SPECIAL MEETING OF THE PLAN COMMISSION OF THE VILLAGE OF WILLOWBROOK TO BE HELD ON WEDNESDAY, MAY 18, 2016 AT 7:00 P.M. AT THE BURR RIDGE POLICE DEPARTMENT TRAINING ROOM, 7700 S. COUNTY LINE ROAD, BURR RIDGE, ILLINOIS

## STAFF REPORT TO THE PLAN COMMISSION

**Case Number and Title:** PC 16-06:/Taste of Sham (\*expected name, subject to change)

<b>Public Hearing Date:</b>	May 18, 2016 (Special Meeting)		
<b>Prepared By:</b>	Jo Ellen Charlton, Planning Consultant		
<b>Case Title:</b>	16-07: Compass Event Center, 635 Joliet Road		
<b>Petitioner:</b>	Willowbrook 2012, LLC, 15 W. 580 N. Frontage Road, Suite 1, Burr Ridge, IL 60527		
<b>Action Requested by Applicant:</b>	Consideration of a petition for a special use permit for a Planned Unit Development, including such relief, exceptions and variations from Title 9 and Title 10 of the Village Code.		
<b>Purpose:</b>	Develop a 45,934 square foot facility that includes a 28,992 square foot indoor soccer facility, and 16,562 square feet of restaurant, bar and golf simulator entertainment spaces; and approval of a Preliminary and Final Plat of PUD.		
<b>Location:</b>	South side of Frontage Road between Del Rhea's Chicken Basket and 7-11

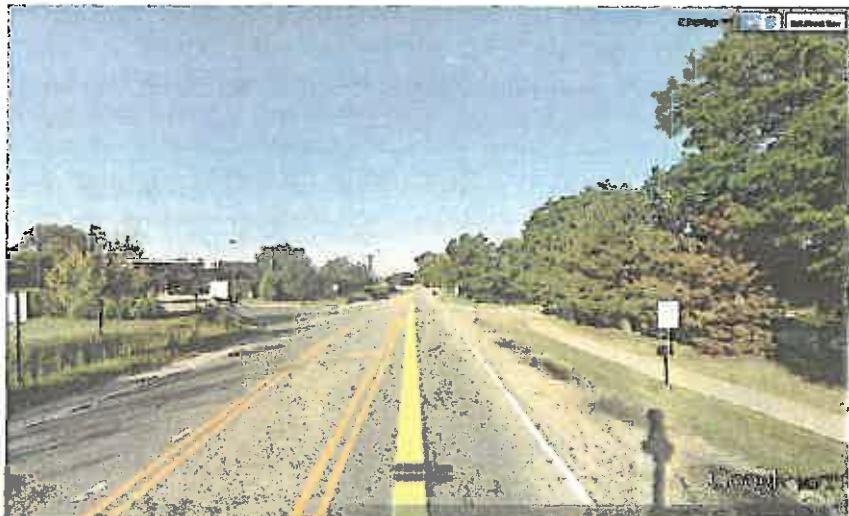
The design of the Joliet Road improvements needs to discourage this illegal parking, as the wide shoulders, when combined with a popular destination that may have a full parking lot will encourage additional illegal parking by semis as well as autos because "it's easier".

As mentioned above, the Comprehensive Plan suggests an urban cross section, and staff will recommend Compass improve to that standard, unless they would like to propose an alternative design that will successfully discourage illegal parking on the sides of the road adjoining this project. One or two trucks parking along the side of the road now when traffic and activity are lighter are one thing. That many or more trucks when combined with the traffic and activity of a successful mixed use soccer arena project will cause visibility and other significant safety concerns

## ARCHITECTURAL SITE PLAN

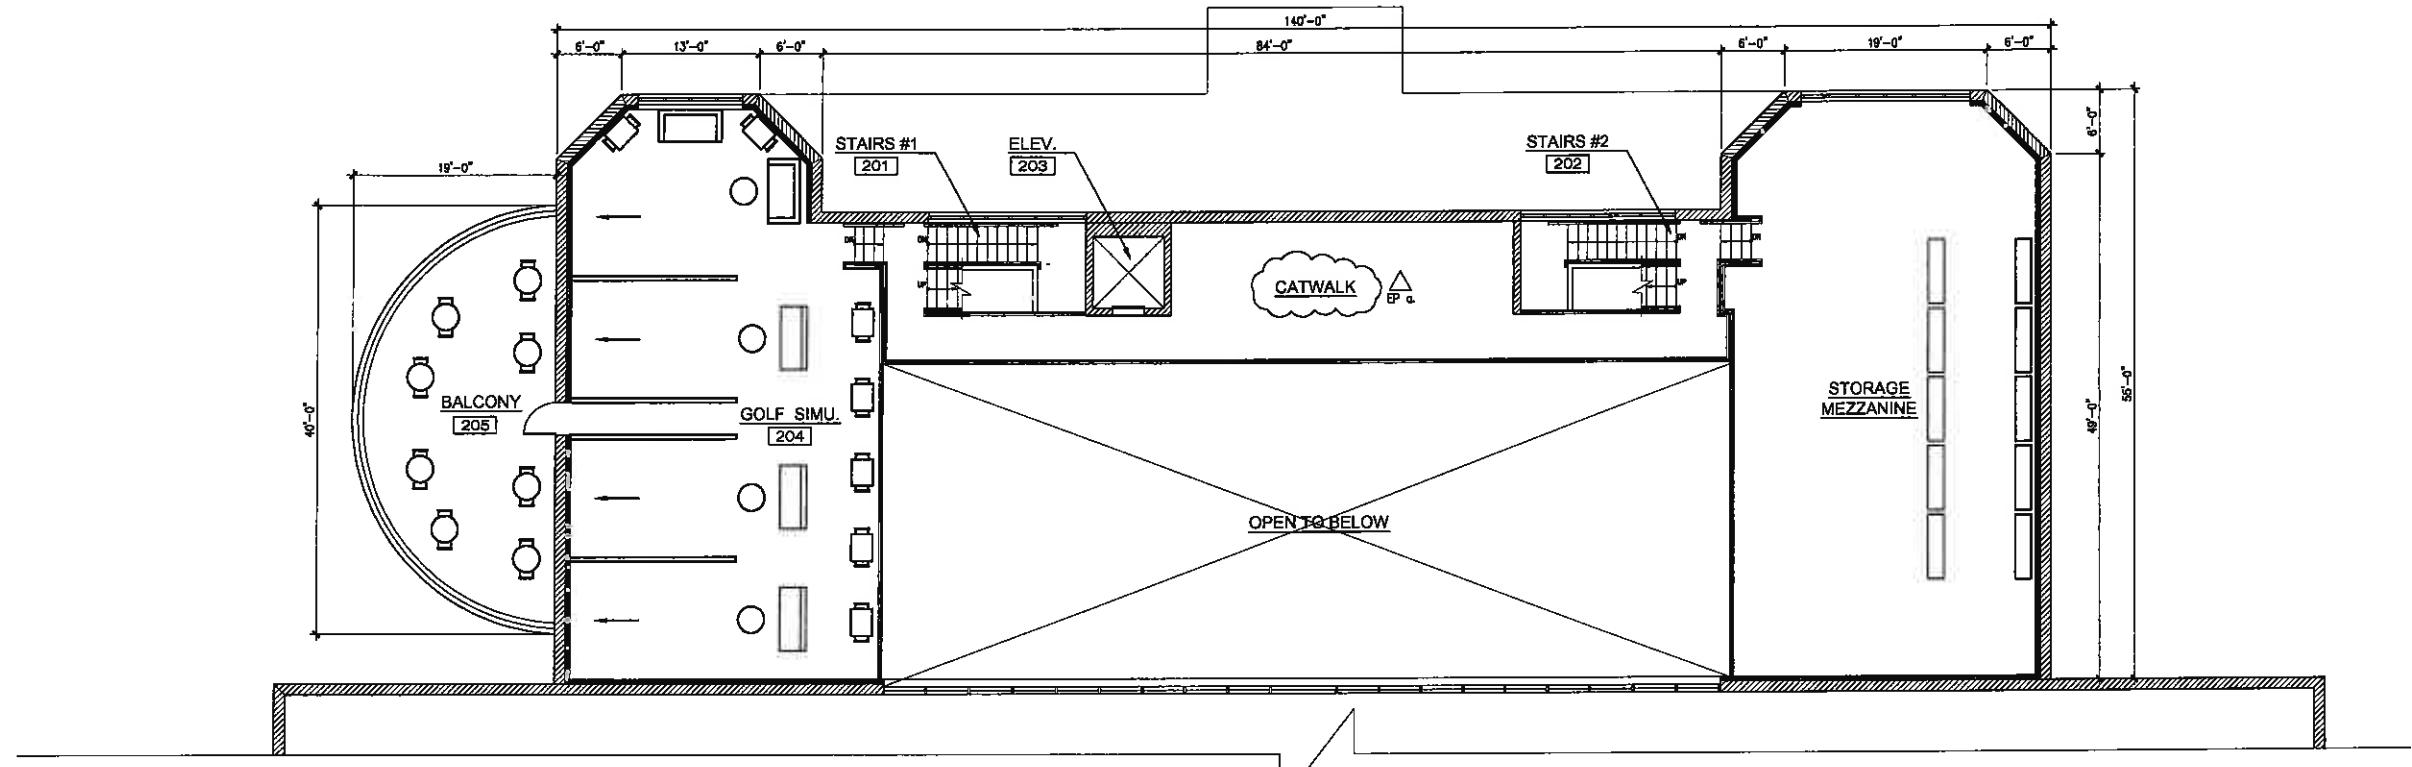
After removing the basement use from their concept plan, the number of parking spaces designed for the site more closely meets the parking requirements of the Zoning Ordinance. The applicant's parking calculations can be found on Sheet "T" of the Architectural Site Plan Documents and show a surplus of about 20 parking spaces. The spreadsheet on the preceding page (Table 1) verifies most of the applicant's numbers, except that 380 square feet was added to account for the outdoor seating on the Second Floor, which requires an addition four (4) parking spaces. Finally, parking was re-calculated for the large 1,654 square foot second floor storage area to measure the impact if that space was converted to more restaurant/bar/party space. If this space was to be converted to anything other than storage as indicated on the plans, parking on the site would be short by a few spaces.

1. The outdoor area shown in the mezzanine shall be added to the parking table in the architectural site plan documents.
2. Joliet Road shall be improved to an urban cross section, or an approved alternative that discourages on-street semi truck parking.
3. Digital wall signs shall not be allowed.
4. The monument sign shall be reduced in size to or near the maximum 90 square feet in area, including digital technology if desired, and relocated so that it is no closer than five feet (5') from the property line.
5. The round compass sign on the front elevation shall be reduced in size to fit under the second floor patio barrier.
6. The plans shall specify that fire hydrant locations to be approved by Tri-State Fire Protection District.

**GEOMETRIC PLAN &  
STRIPING PLAN  
LIGHTING PLAN**

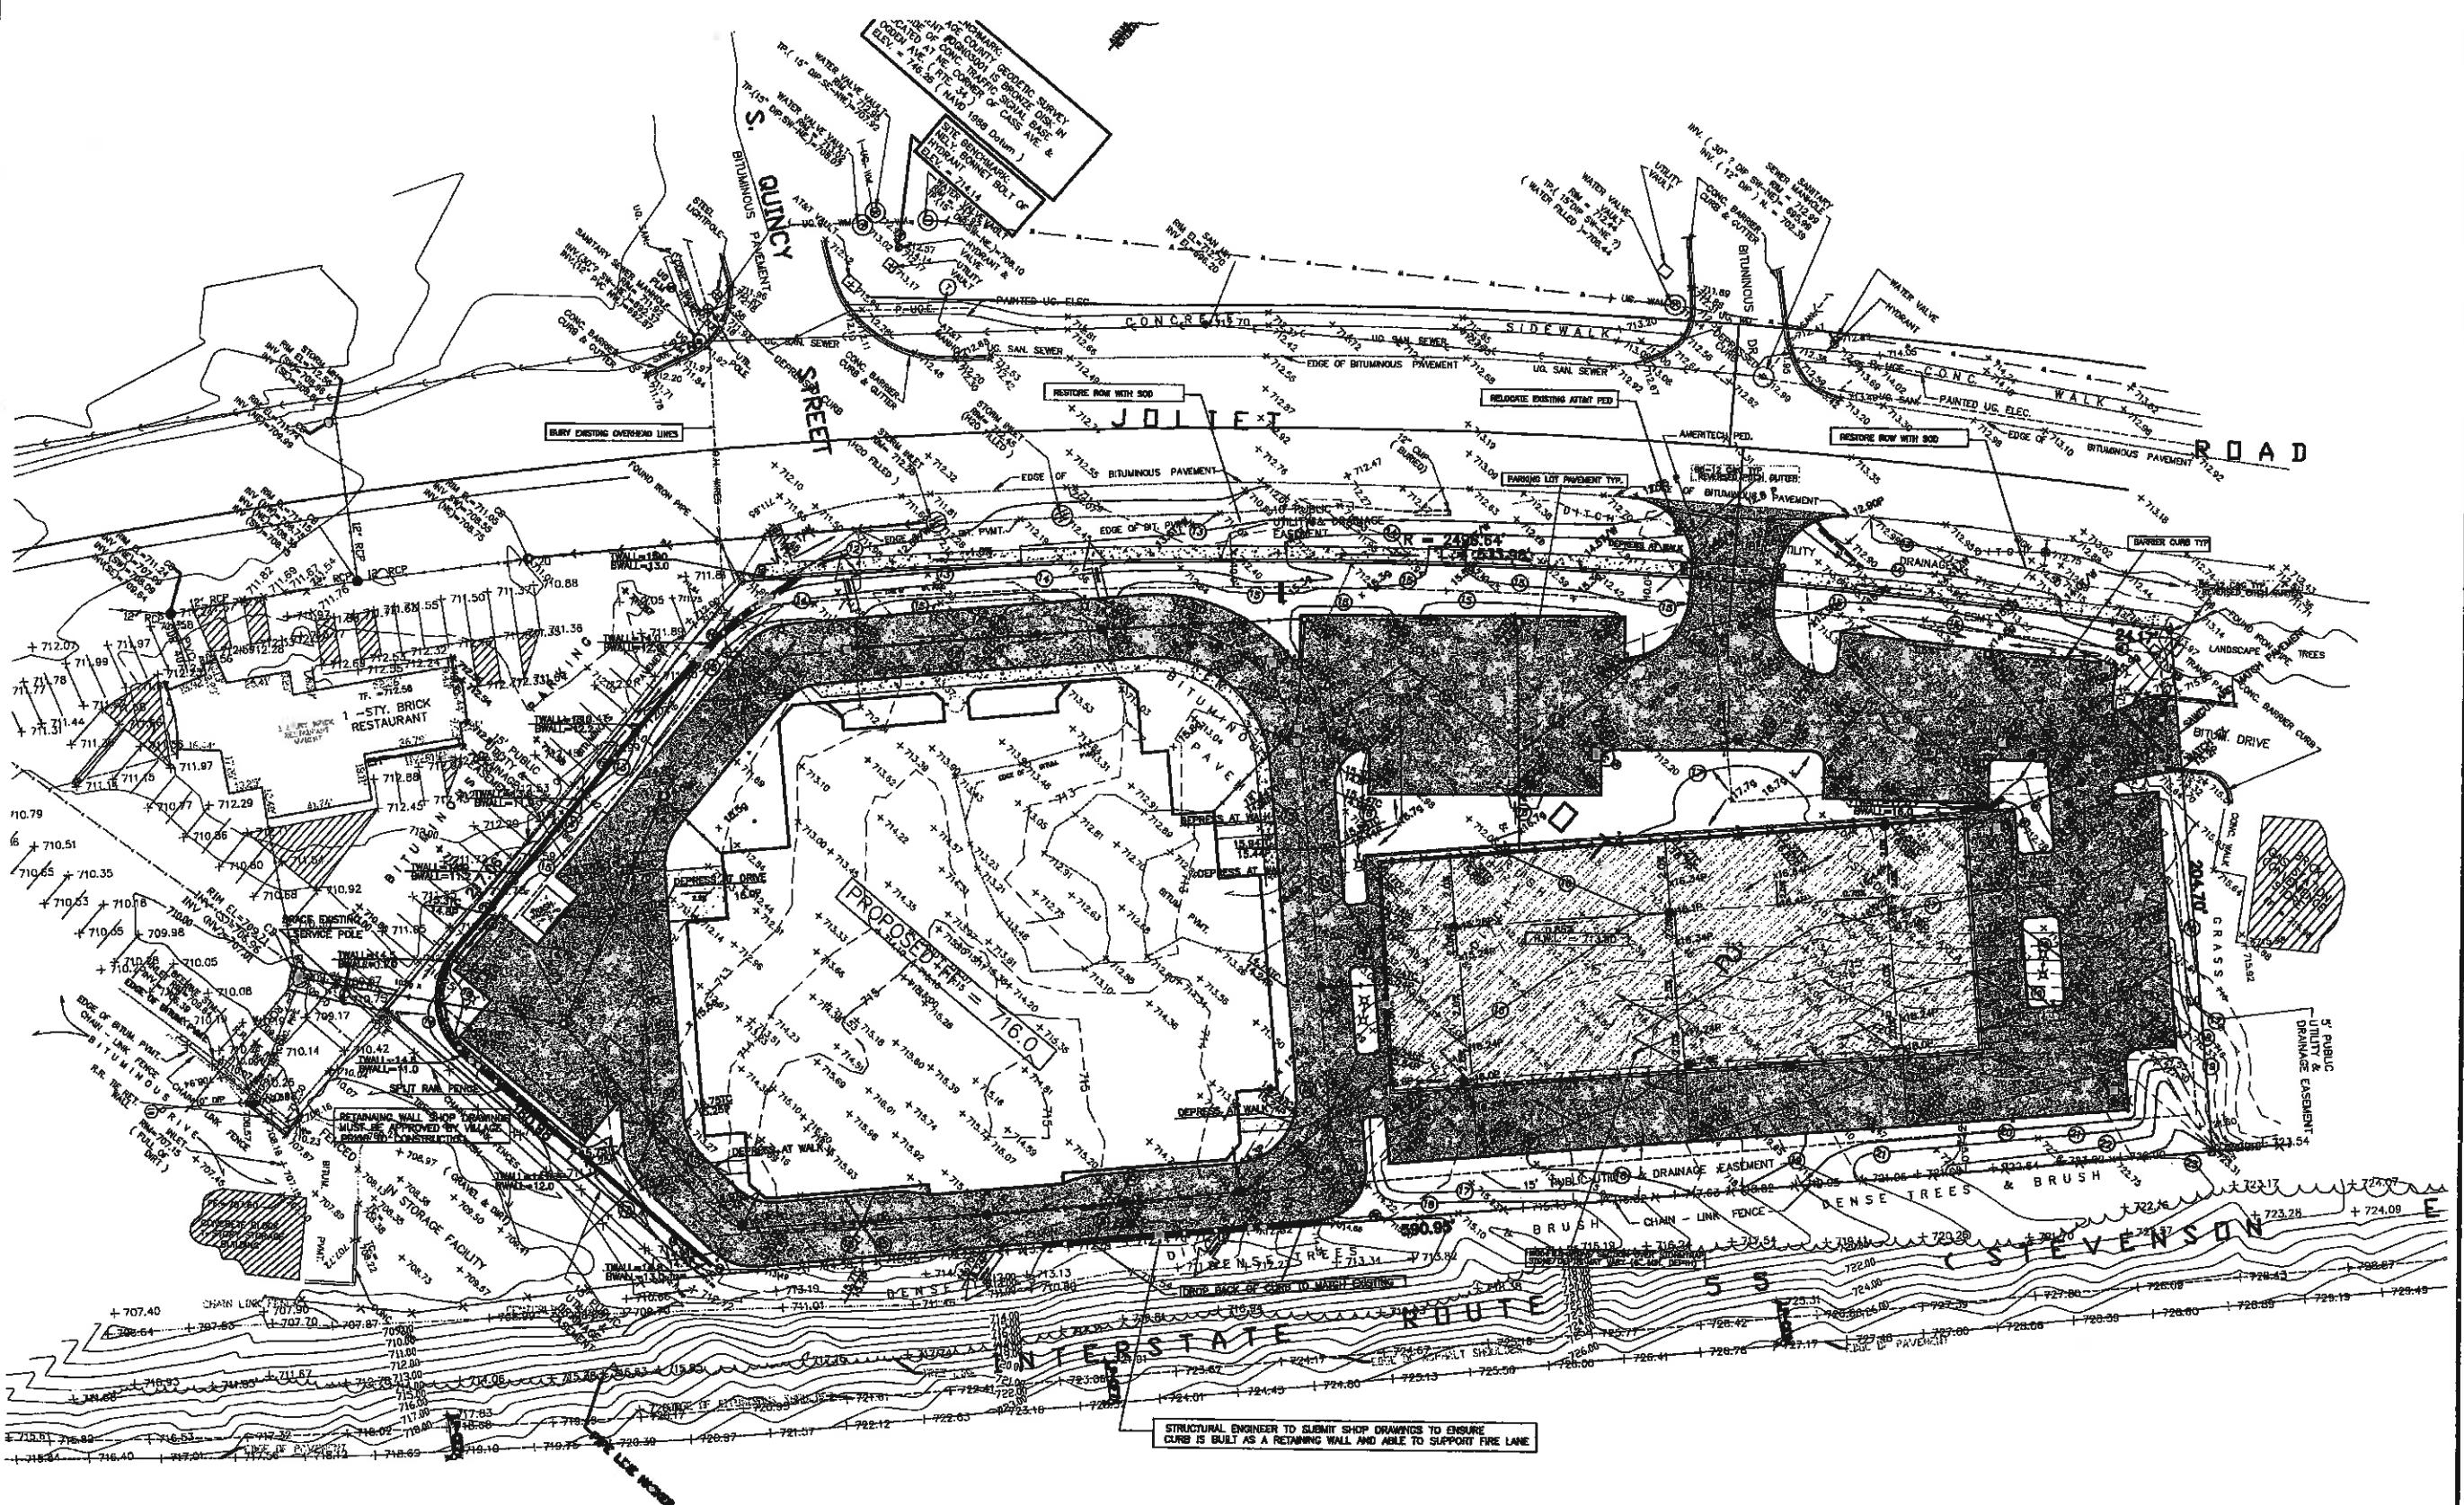
2. The light pole locations on the engineering plans do not match the photometric, or on the landscape plan. Plans should be coordinate, and with regard to the landscaping plan, landscape islands that do not have light standards should incorporate the standard shade tree in lieu of shorter ornamental trees.
